# Access Compliance Report

## Public Rights-of-Way

### (Curb Ramps)

Intersection ID: N/A	Main Street: COSTIGAN_LN	Cross Street: N/A	Location: NE
ADA ID: BA36EDD33121	Ramp Type: PerpDiag	Initial Pass/Fail: Fail	Overall Compliance: No
Severity Score: 21.25			
Codes/Mitigation Info/Possible Solution		Field Measurements/Component Compliance

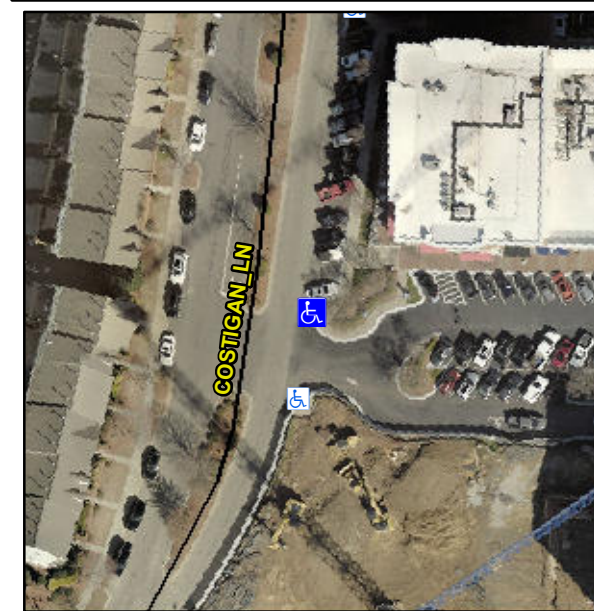
**Not Found, R304.5.1, R304.5.3**

Compliance	Description	Data	Compliance	Description	Data
N/A	Ramp Length (in)	59.0	Yes	Ramp Slope (%)	7.2
No	Ramp Width (in)	45.0	No	Ramp XSlope (%)	5.9
N/A	Flare Type LT	N/A	N/A	Flare Type RT	N/A
N/A	Flare Slope LT (%)	N/A	N/A	Flare Slope RT (%)	N/A
N/A	Flare Traversable LT?	N/A	N/A	Flare Traversable RT?	N/A
N/A	Landing Length (in)	N/A	N/A	DWS Provided?	N/A
N/A	Landing Width (in)	N/A	N/A	DWS Contrast?	N/A
N/A	Landing Slope (%)	N/A	N/A	DWS Length (in)	N/A
N/A	Landing X Slope (%)	N/A	N/A	DWS Full Width?	N/A
N/A	Landing Curb? (Y/N)	N/A	N/A	DWS Offset (in)	N/A
N/A	Shared Landing?	N/A			
N/A	Gutter Ponding?	N/A	N/A	Gutter Slope (%)	N/A
N/A	Gutter Lip Ht (in)	N/A	N/A	Gutter X Slope (%)	N/A
N/A	Painted X Walk1?	No	N/A	Painted X Walk2?	No
	X Walk 1 Direction	To W		X Walk 2 Direction	To S
N/A	X Walk 1 Width (in)	N/A	N/A	X Walk 2 Width (in)	N/A
	X Walk 1 Slope (%)	1.0		X Walk 2 Slope (%)	0.4
	X Walk 1 X Slope (%)	0.3		X Walk 2 X Slope (%)	5.7

**Remove & Replace Curb Ramp With Two New Directional Ramps or Equivalent.**
